July 22, 1986
G02-86-679

Docket No. 50-397

Subject: NUCLEAR PLANT NO. 2
INSERVICE INSPECTIONS AND INSERVICE
TESTING PROGRAMS AND RESPONSE TO
REQUEST FOR INFORMATION

RESPONSE TO NRC's
REQUEST FOR ADDITIONAL INFORMATION
FOR WASHINGTON PUBLIC POWER SUPPLY SYSTEM
WPPSS NUCLEAR PLANT NO. 2
DOCKET NUMBER 50-397

WNP-02
INTERVAL: 01
DRAWING NO. RHR-208

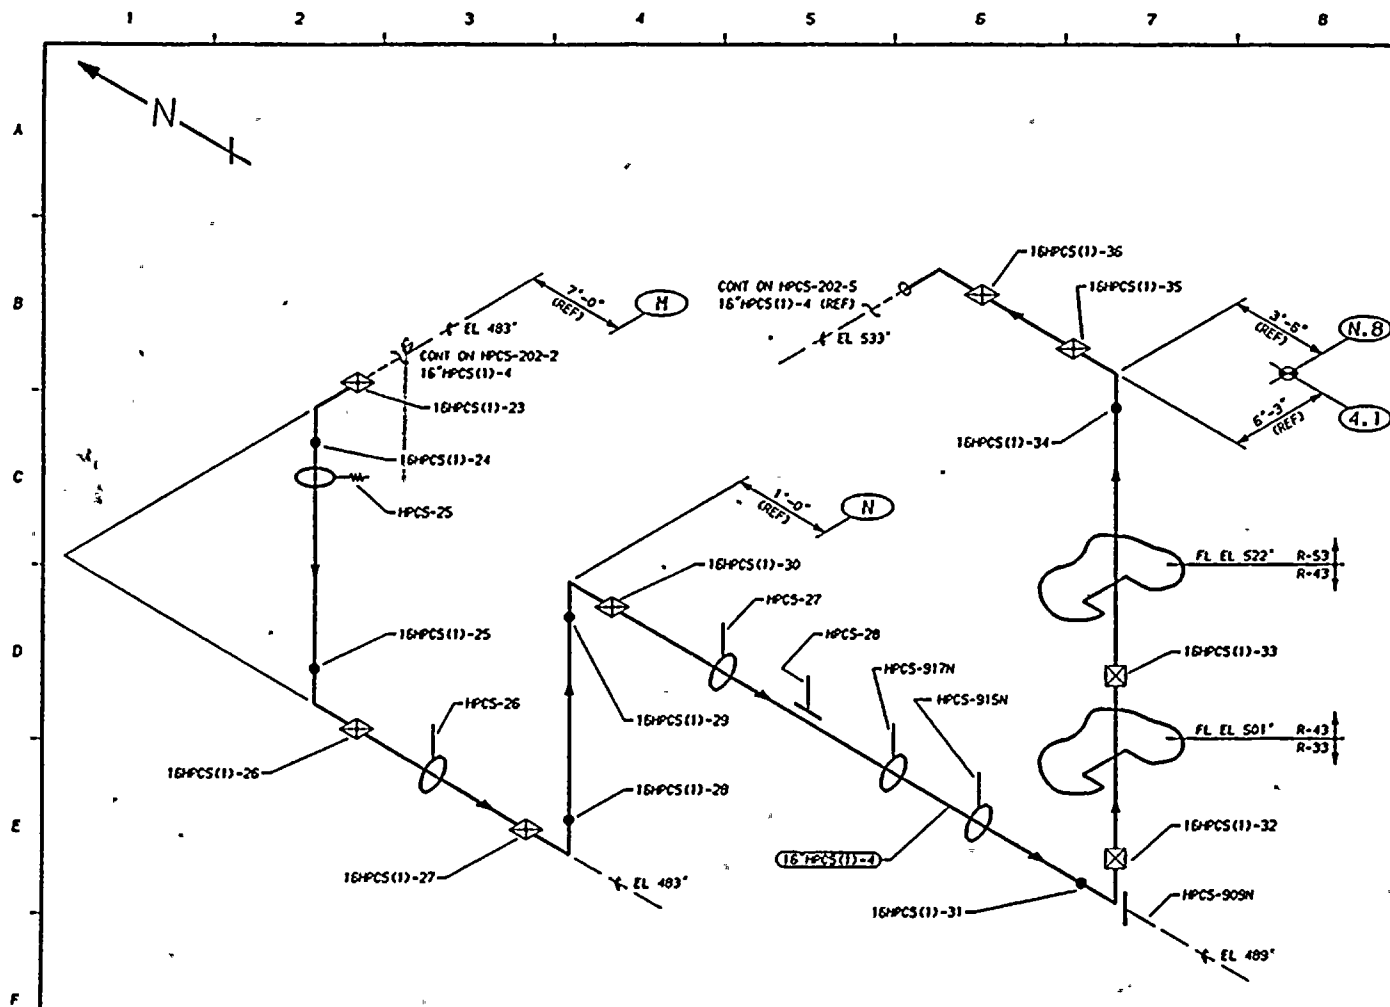
- A. In Section 14.0, "Weld and Component Identification Diagrams," of the ISI Program Plan, the Program Plan and Schedule Tables list the following welds as being inspected to Table IWC-2500-1, Examination Category C-F-2, Item C5.51 of the Code with only surface examination being required:

To satisfy the inspection requirements of Item C5.51, these welds require both surface and volumetric examinations. Clarification of this issue is needed.

The Supply System revised the WNP-2 ISI Program Plan and has included in it a surface and volumetric examination requirement for each of the above listed welds. Attached markups reflect this change.

IDENT. NO.	DESCRIPTION	SECT. XI EXAM.	ITEM NO.	EXAM MTH.	CAL. BLOCK	SCHEDULED PER.	OUTAGE	REQ.	NOTES
RHR-581									
18RHR(20)8-4	STRUT	IWF	F-X	VT3H				F	
	PIPE TO TEE	C-F-2	C5.51 C5.51	SUR VOL				F8 F8	
RHR-569	PSA-3 SNUBBER	N/A	N/A	N/A				OT	S/N
RHR-570	PSA-3 SNUBBER	N/A	N/A	N/A				OT	S/N
RHR-568	SPRING	N/A	N/A	N/A				OT	
RHR-567	STRUT	N/A	N/A	N/A				OT	
RHR-566	STRUT	N/A	N/A	N/A				OT	
RHR-969N	ANCHOR	N/A	N/A	N/A				OT	
RHR-960N	PSA-1 SNUBBER	N/A	N/A	N/A				OT	S/N
RHR-961N	PSA-3 SNUBBER	N/A	N/A	N/A				OT	S/N
RHR-1003N	STRUT	N/A	N/A	N/A				OT	
RHR-938N	PSA-1 SN(2)	N/A	N/A	N/A				OT	S/N
RHR-930N	STRUT	N/A	N/A	N/A				OT	
RHR-939N	PSA-3 SNUBBER	N/A	N/A	N/A				OT	S/N
RHR-957N	PSA-3 SNUBBER	N/A	N/A	N/A				OT	S/N

DWG NO: HPCS-202-4

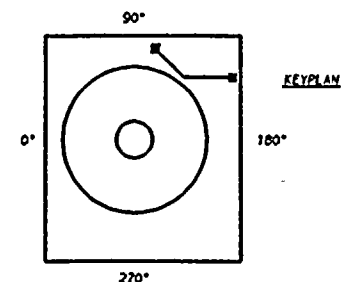
- B. Isometric Drawing No. HPCS-202-4 is missing from the ISI Program Plan. Provide the staff with a copy of this drawing.

Enclosed is a copy of ISI weld and identification diagram HPCS-202-4, Rev. 2. This drawing was being revised and inadvertently omitted.
